**PLANNING APPROVAL,
PLANNED UNIT DEVELOPMENT &
SUBDIVISION STAFF REPORT****Date: August 21, 2014**

<u>NAME</u>	Smith Memorial AME Church
<u>SUBDIVISION NAME</u>	Smith Memorial AME Church
<u>LOCATION</u>	6501 Felhorn Road North (Southwest corner of Felhorn Road North and Roslyn Drive West)
<u>CITY COUNCIL DISTRICT</u>	District 4
<u>PRESENT ZONING</u>	R-1, Single-Family Residential District
<u>AREA OF PROPERTY</u>	1 Lot / 1.0± Acre
<u>CONTEMPLATED USE</u>	Planning Approval to allow the expansion of an existing church in an R-1, Single-Family Residential District, Planned Unit Development approval to allow a reduced side yard setback, and Subdivision approval to create one legal lot of record.
<u>TIME SCHEDULE FOR DEVELOPMENT</u>	None given..
<u>ENGINEERING COMMENTS</u>	
<u>TRAFFIC ENGINEERING COMMENTS</u>	Site is limited to the existing curb cuts on Felhorn Road N and Roslyn Drive W, with size, location and design to be approved by Traffic Engineering and conform to AASHTO standards. In the future when the parking lot is resurfaced, the parking lot layout should be reconfigured to provide as many conforming parking spaces as possible on this site.

EXISTING SITE PLAN

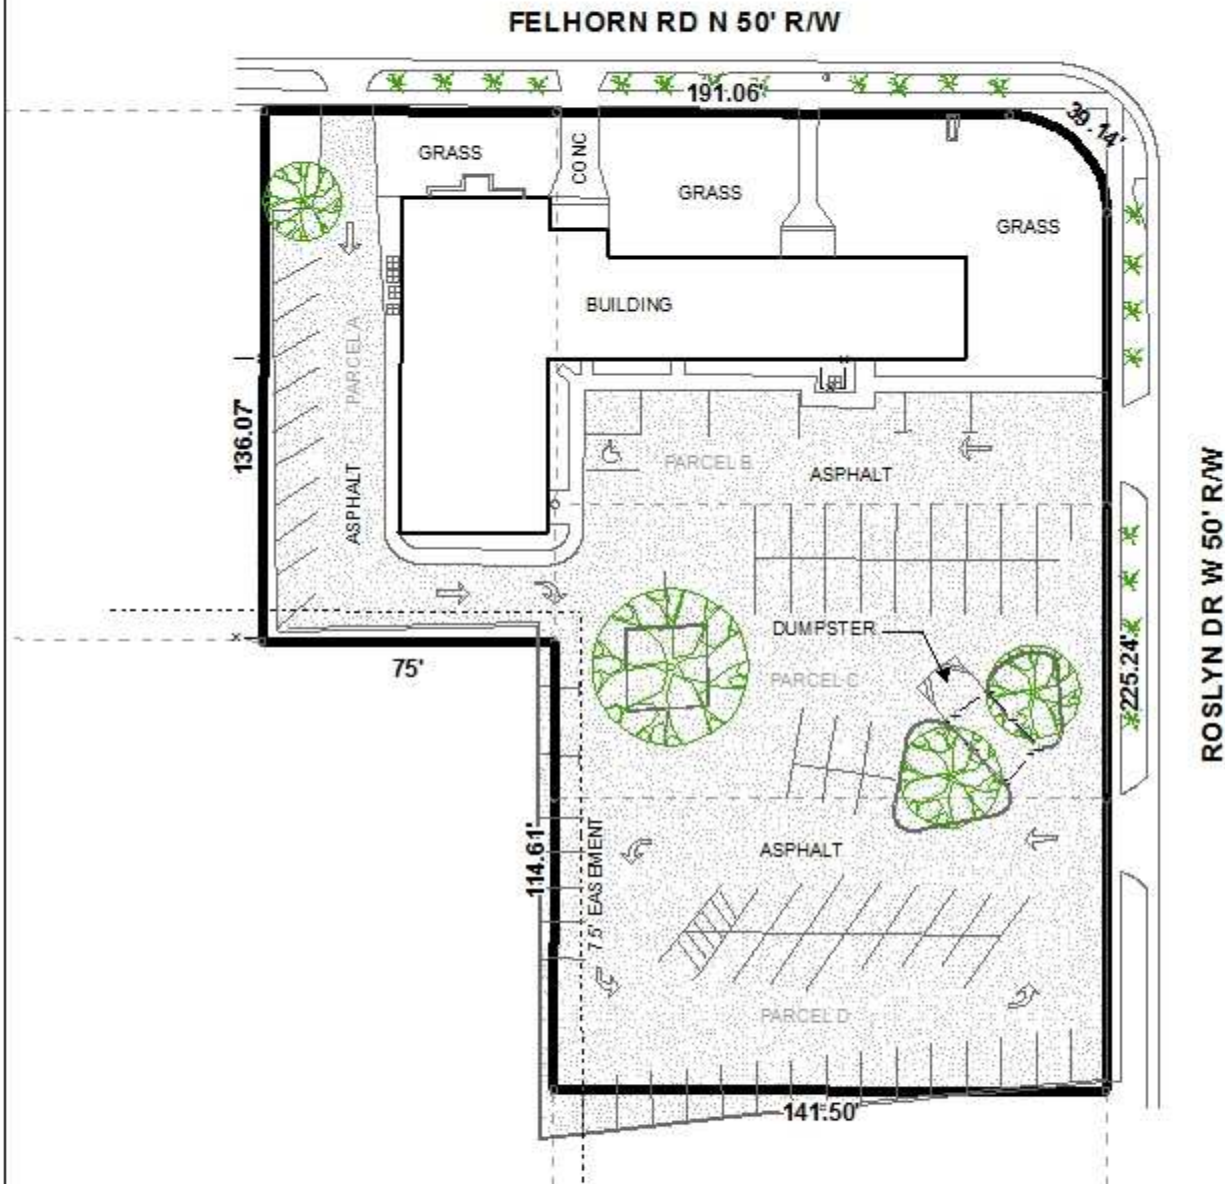
A comparison of the PUD and Planning Approval site plans with the Subdivision survey indicates a discrepancy in both the front and side street yard setbacks for the existing church building. The site plans indicate the sanctuary portion right at the 25' front setback and the East wing at a scaled 38'± front setback, with the Rosalyn Avenue (East end) of the remaining portion at a 37'-4" setback off the Rosalyn Avenue property line. However, the survey indicates a 22' front setback for the sanctuary and a 36'-11" front setback for the East wing, with a 36' setback for the remaining portion off Rosalyn Avenue. The narrative provided does not give a specific requested setback off the Rosalyn Avenue right-of-way. Since PUD's and Planning Approvals are site plan specific, and since staff cannot determine the actual setback requested due to the discrepancies, it is recommended that these applications be heldover to the meeting of September 18th to allow the discrepancies to be cleared.

Also, in verbal conversations with the applicant's professionals, it has been indicated that the retaining wall and parking area encroachments onto adjacent properties along the West and South property lines have been corrected as is indicated on the site plans but not on the survey for the preliminary plat. However, no permits were obtained for such. In the event the encroachments have been corrected, the plat should be revised to indicate such.

- 1) revision of the plat as necessary so that existing front and side street setbacks can be corrected, and proposed setbacks for the kitchen addition can be shown, to match those of the Planned Unit Development and Planning Approval site plans;
- 2) revision of the plat to indicate the correction of the parking area and retaining wall encroachments onto adjacent properties to the West and South, if such have been corrected.

PROPOSED SITE PLAN

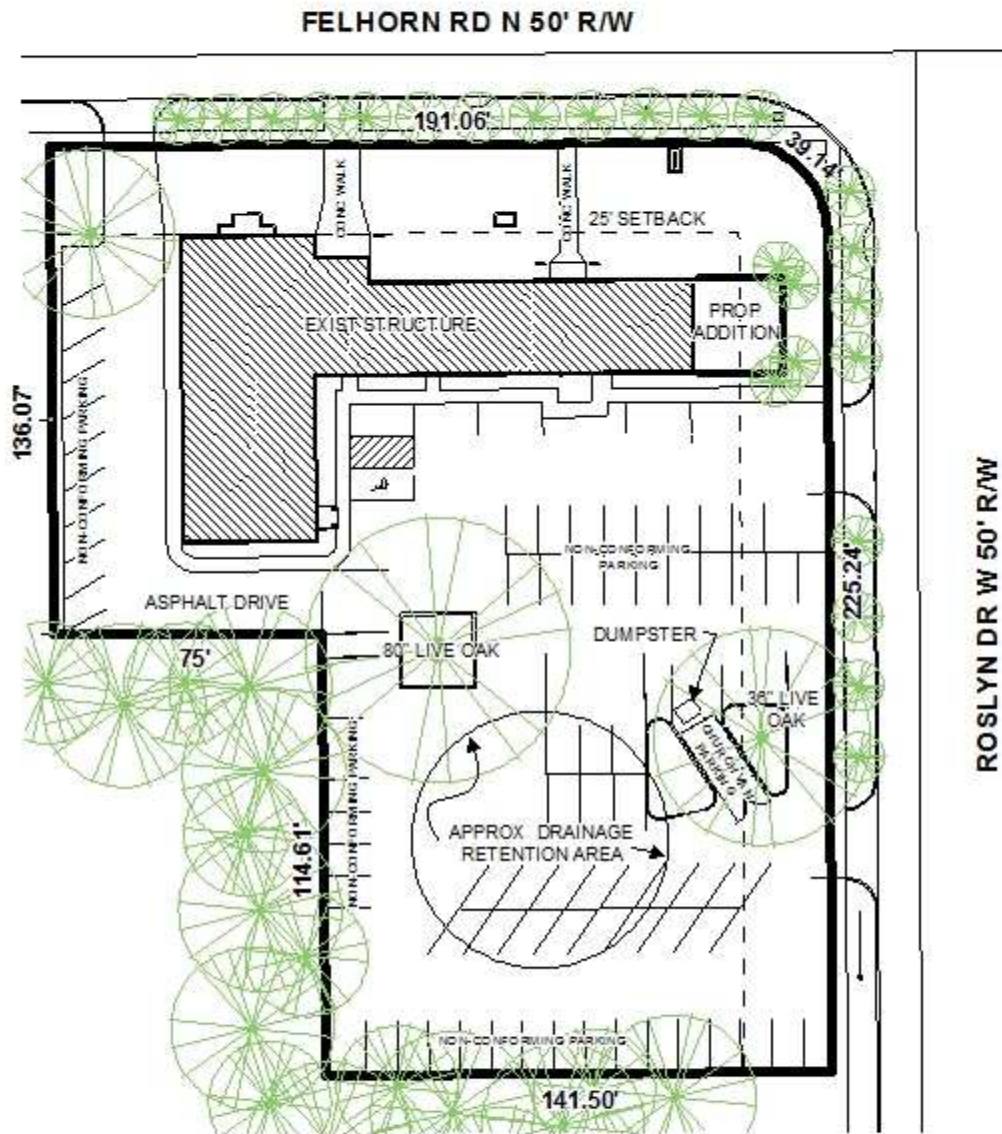
The narrative supplied indicates that the church has a 400-person seating capacity which would require 100 on-site parking spaces. However, only 75 are provided, and the site has no room to provide expanded parking facilities. Some new spaces could possibly be obtained by a re-configuration of the existing parking lot, but no such attempt was made for the PUD and Planning Approval applications. Even with a more-compliant parking plan, the site would still not provide space to construct the proposed kitchen expansion to meet the required 25' side yard setback along Rosalyn Avenue. The same situation would arise attempting to build to the front toward Felhorn Drive. The proposed addition is indicated to be 25' by 26'-5" and indicated to extend to within 12'-4" of the Rosalyn Avenue property line, thus the setback relief of the PUD request.

- 1) revision of the site plan as necessary so that existing and proposed front and side street setbacks will match those of the Subdivision survey;
- 2) revision of the narrative to explain precisely what side street setback is requested.

- 1) revision of the site plan as necessary so that existing and proposed front and side street setbacks will match those of the Subdivision survey;
- 2) revision of the narrative to explain precisely what side street setback is requested.
